APPLICATION NO.	FILING DATE	FIRST NAMED INVENTOR	ATTORNEY DOCKET NO.	CONFIRMATION NO.
10/633,368	07/31/2003	Michael R. Layton	A-71673/ESW	5135

Office Action Summary	Application No. 10/633,368	Applicant(s) LAYTON ET AL.	
	Examiner Amy J. Sterling	Art Unit 3632

This is the first Office Action for application number 10/633,368 Shock-Resistant Enclosure, filed on 7/31/03. Claims 1-35 are pending.

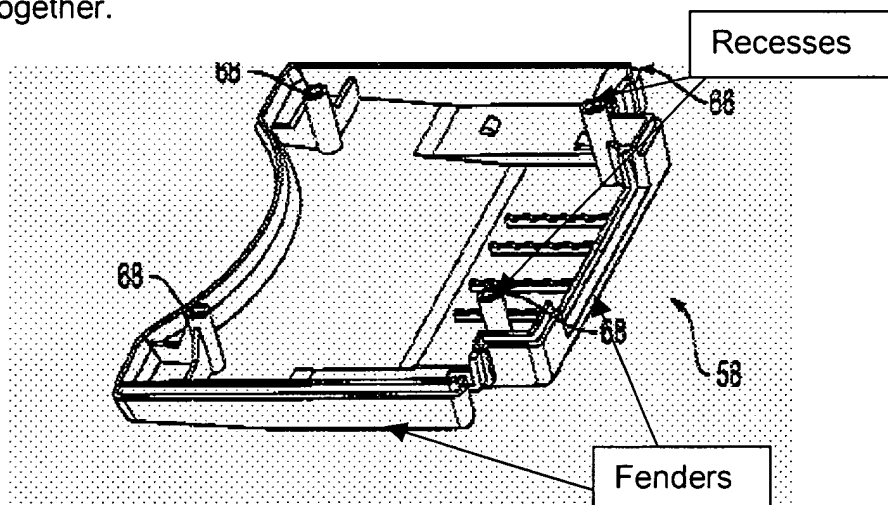
Claims 1-3, 6-12, 17-20 and 32 are rejected under 35 U.S.C. 102(e) as being anticipated by United States Patent No. 6454250 to Ribeiro.

The patent to Ribeiro discloses a shock-resistant enclosure (54, 56, 58) having a housing to which a fragile element is rigidly mounted (electronic component, See Col. 3 line 64) and a plurality of integrally formed elastomeric (See Col. 3, line 63 for material) discrete shock absorbing elements (54, projections being sides 74, 76) projecting in

different directions and from different sides of the housing and extending beyond a mounting surface of the housing, wherein the shock absorbing elements are a gasket having a sealing portion (74) disposed between the base and cover (56, 58) which seals two sections a base and cover section (56, 58) of the housing together, and shock absorbing elements (62, See Drawing Below) which are formed integrally with the housing and are the same material as the housing which include an integrally formed mounting pad (62) which projects from the housing and integrally formed fenders (See Drawing Below) spaced laterally from mounting pad (62) which extend around corners and are spaced from corner portions of the housing. Riberior also teaches wherein the shock absorbing elements are connected to the sealing portion by runners (78, 80) which are embedded in the walls of the housing and wherein the runners (78, 80) are embedded in recesses (See Drawing Below) near the corners of the housing and held in place by cornerpieces (68) retained by fasteners (60) that also hold the two sections of the housing together.

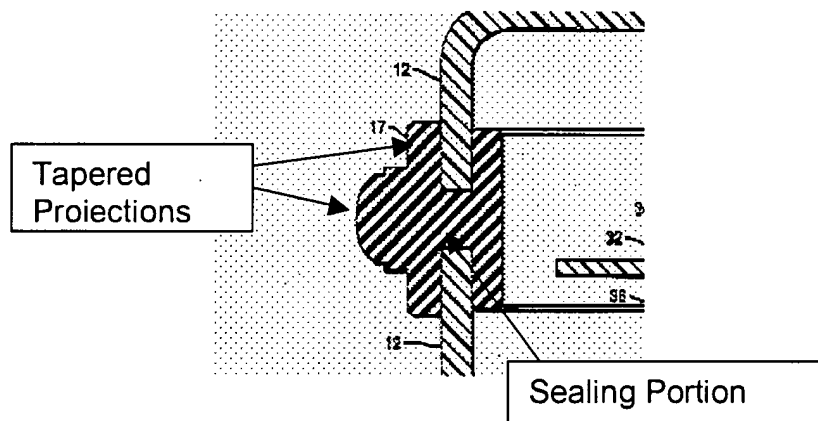
Claims 1, 5, 10 and 14 are rejected under 35 U.S.C. 102(b) as being anticipated by United States Patent No. 5550712 to Crockett.

The patent to Crockett discloses a shock-resistant enclosure (10) having a housing with a base (18) and cover (16) section, to which a fragile element (14) is rigidly mounted and a combined sealing gasket and shock absorbing structure formed integrally of elastomeric material (See Co. 4, lines 21 for material, silicone rubber is considered an elastomer) with a sealing portion (See Drawing Below) disposed between the base and the cover sections of the housing and plurality of discrete shock absorbing elements (17, See Drawing Below) extending from the sealing portion and are projecting from the different sides of the housing, the projections which are tapered and decrease in cross-sectional area away from the housing and are projecting in different directions from the housing.

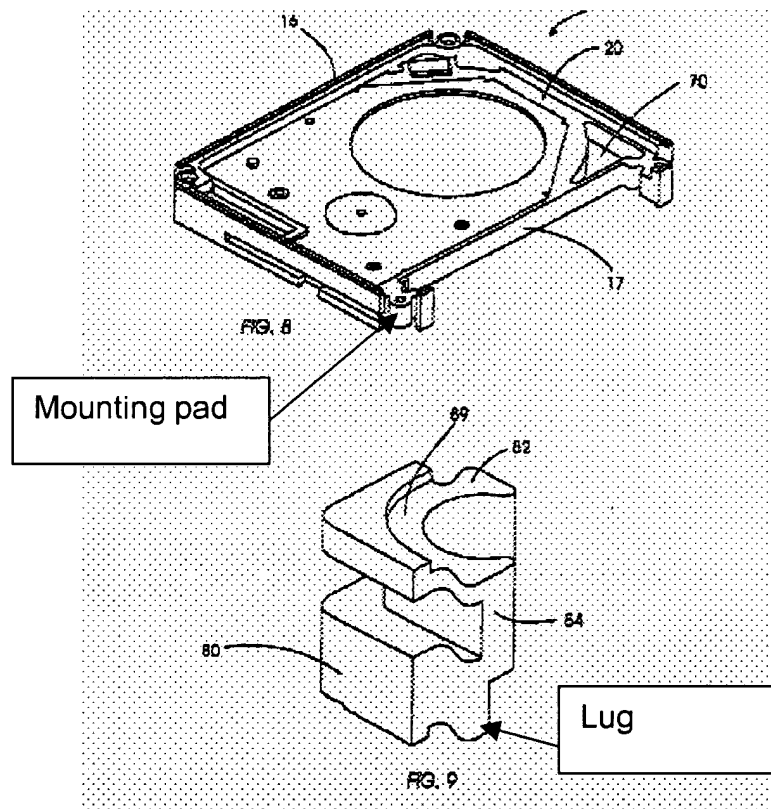
Claims 1, 19, 21, 23, 32, 33 and 35 are rejected under 35 U.S.C. 102(b) as being anticipated by United States Patent No. 6031841 to Albrecht et al.

Albrecht et al. teaches a housing (10) to which a fragile element (40) is rigidly mounted, and discrete shock absorbing elements projecting in different directions from the housing, the shock absorbing elements which include a generally circular mounting pad (See Drawing Below) which projects from the housing and a generally c-shaped shock absorbing fenders (80) which extend around corner portions and are spaced laterally from the corner portion and the mounting pad and the fender which includes a lug (See Drawing Below) which extends beyond a surface of the mounting pad and extend beyond a side of the housing bounded by the corner portions.
